## **NOTICE TO ALL FIRMS**

Re: Addendum Number 1  
IFB # C1536 – Admissions Office Renovation

DATE: 09.01.2022  
PROJECT No: 13284.154  
DRAWING BY: GD & TM  
CHK BY: DH & CK  
DWG No:  
**A-800.SK1**  
SCALE: AS NOTED    53 of 61

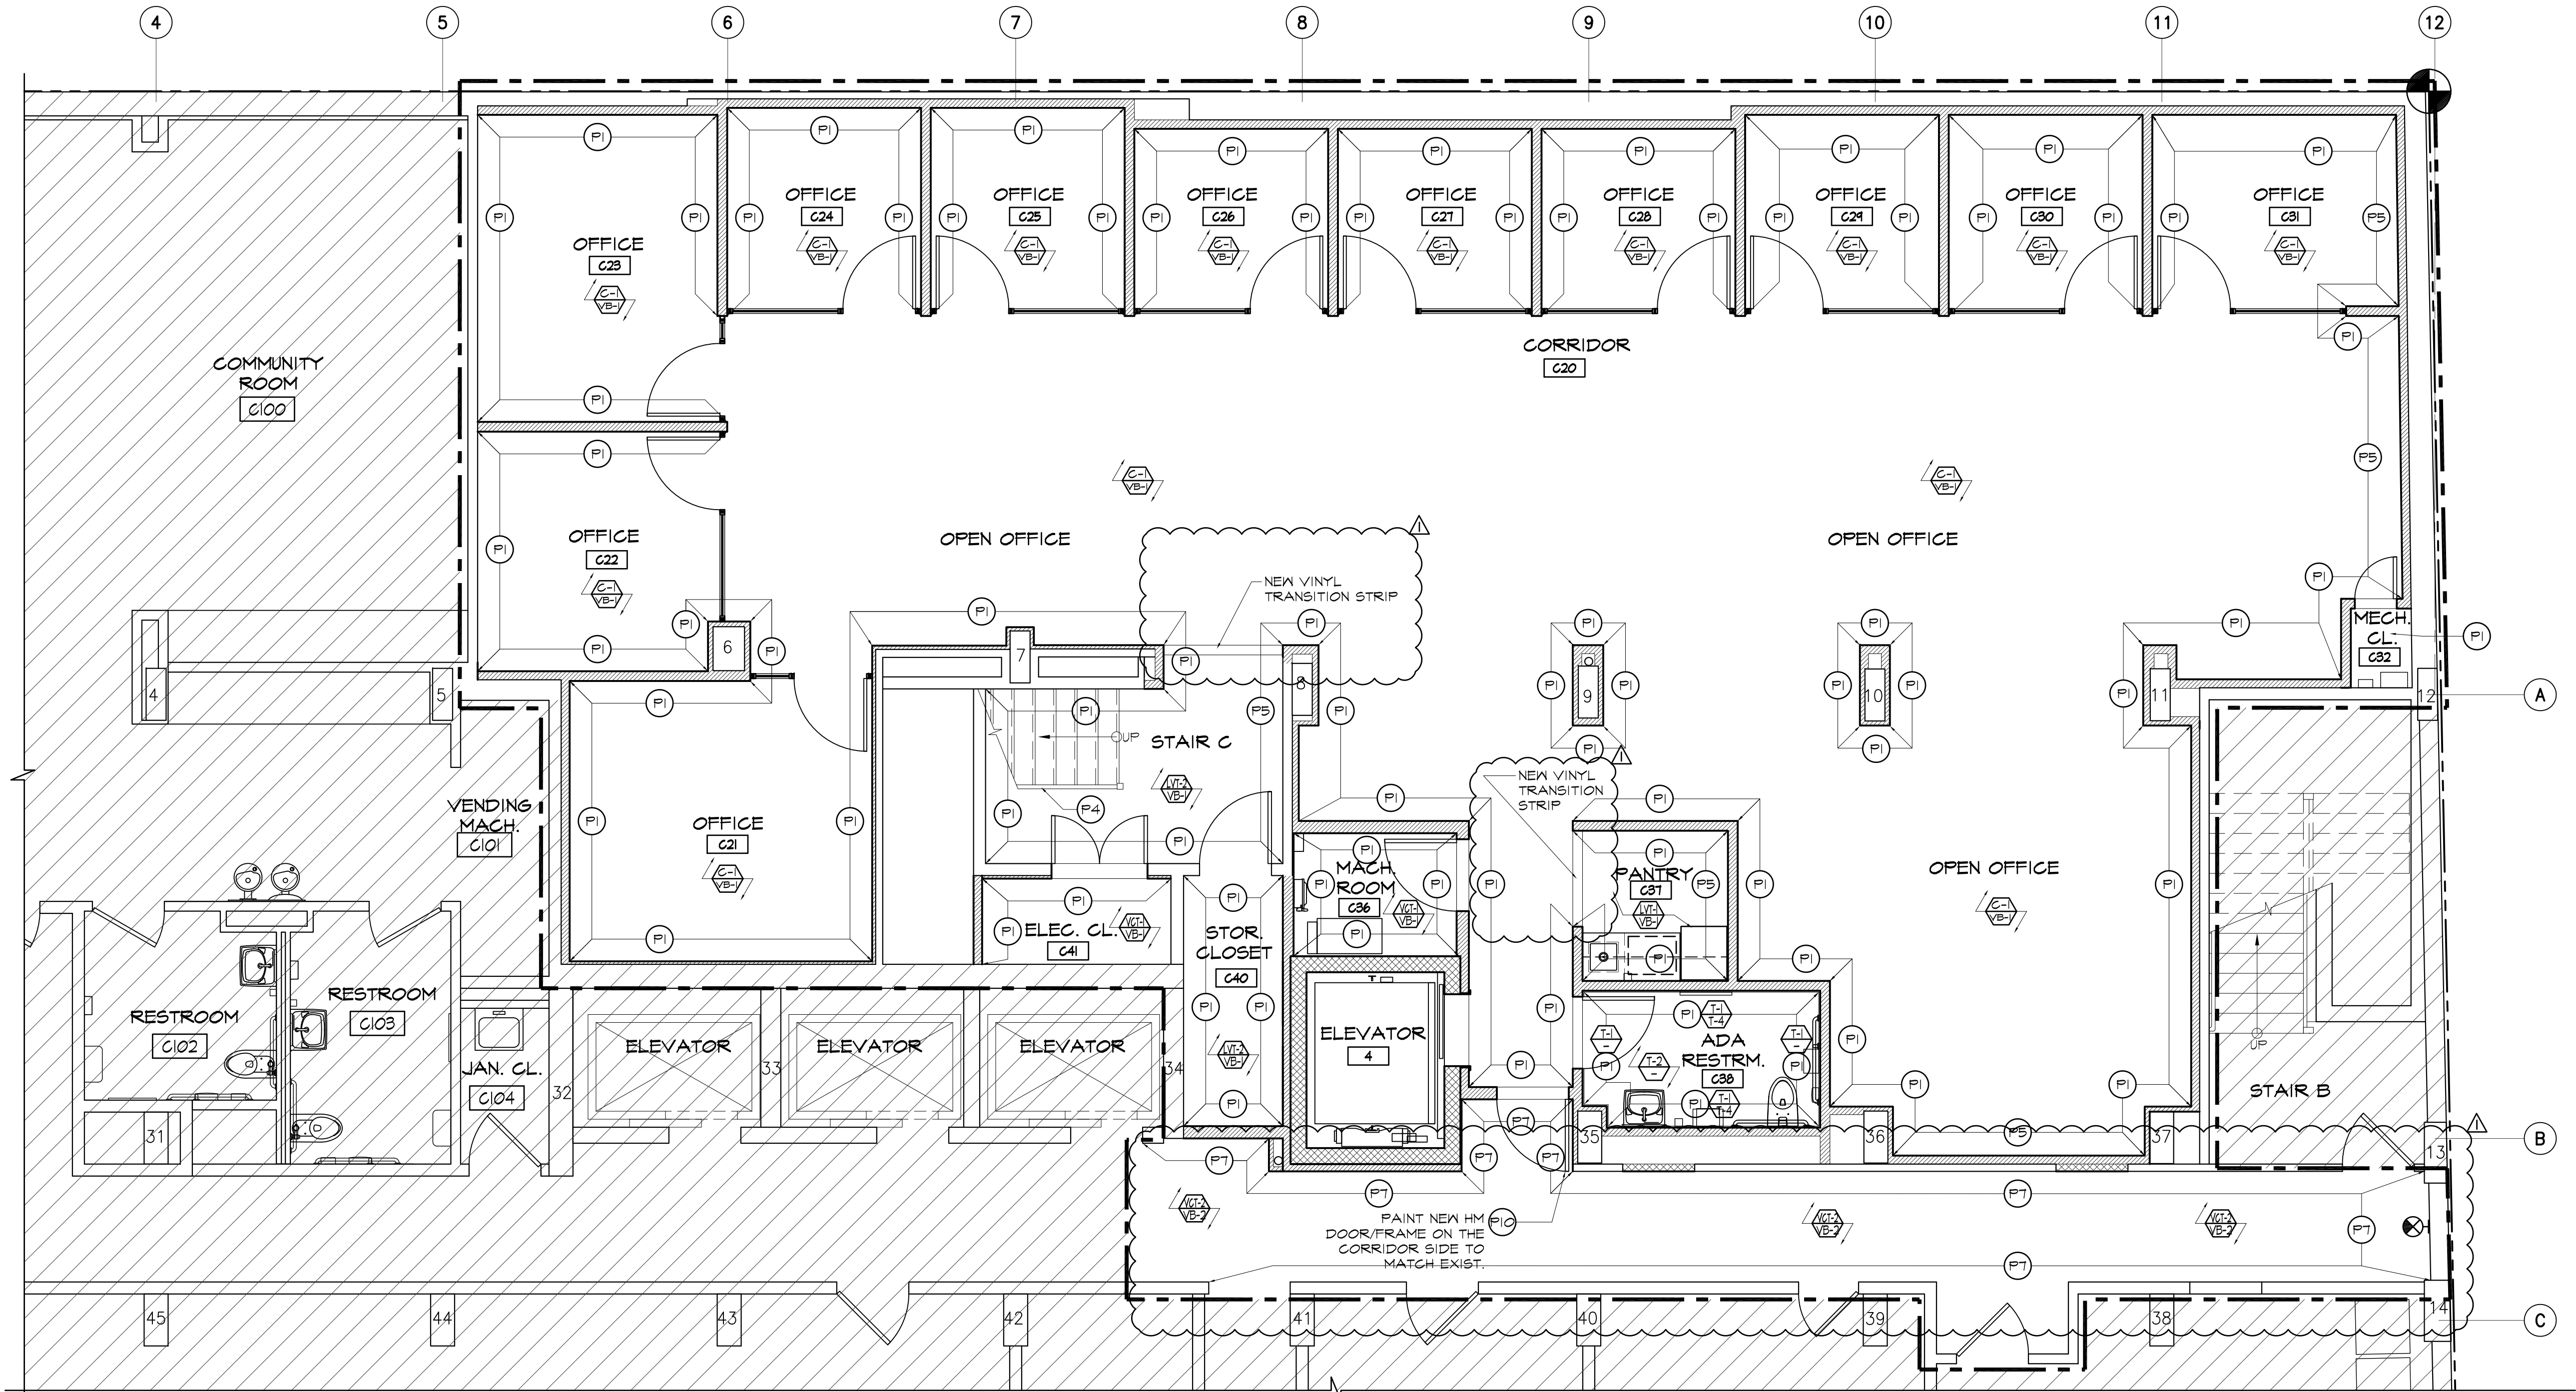
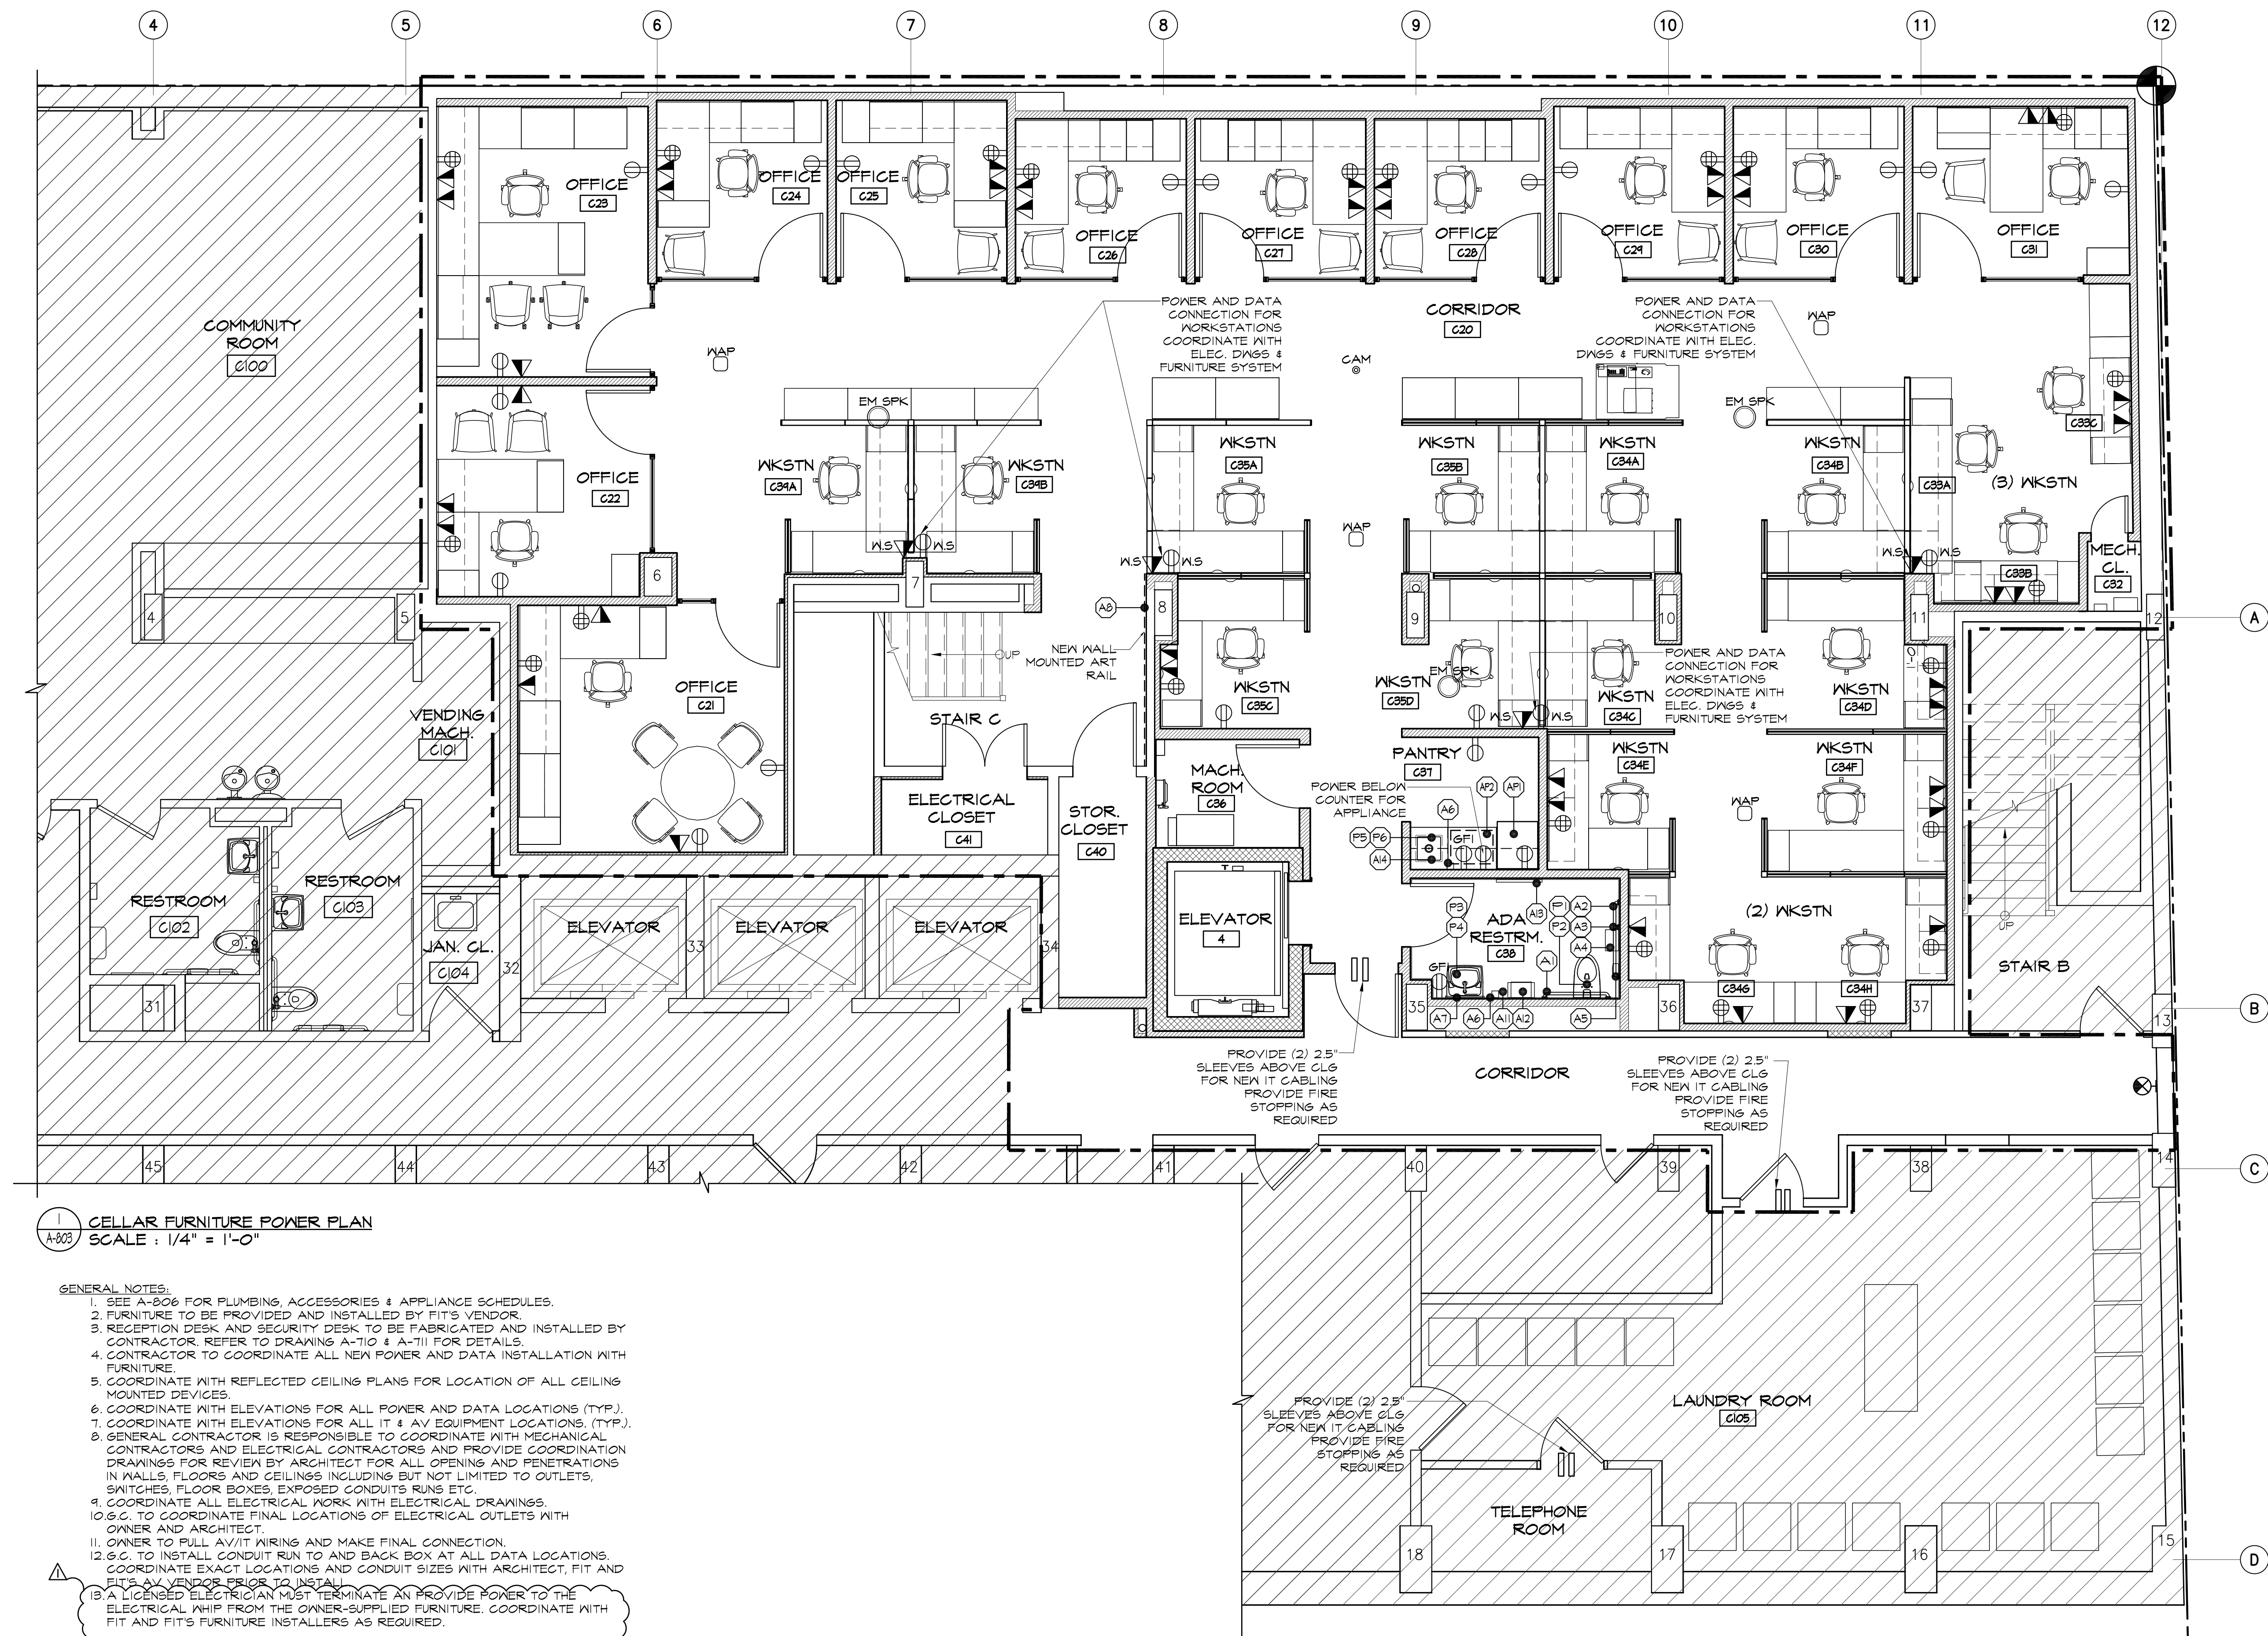
Q8. Please provide transition location for flooring change; C-1 in Open Office to LVT-2 of Stair C on Drawing A-800.00 cellar.

1. Revised electrical scope of work as follows and as indicated in the attached drawings A-803.SK1, A-804.SK1 and E-200. Electrician must terminate and provide power to the electrical whip from the owner-supplied furniture. Coordinate with FIT and FIT's furniture installers as required.
2. Contractor must comply with all requirements of the NYC DOB including but not limited to:
  - a. Submitting a Site Safety Plan to the NYC DOB as per Article 110 of the Administrative Code.
  - b. Providing Construction Superintendent registered with the NYC DOB, as per Chapter 33 of the NY Building Code
3. Contractor to install new flooring, vinyl base and paint walls in cellar corridor as indicated in attached A-800.SK1 Cellar Finish Plan.

A8. **See attached drawing A-800.SK1.**
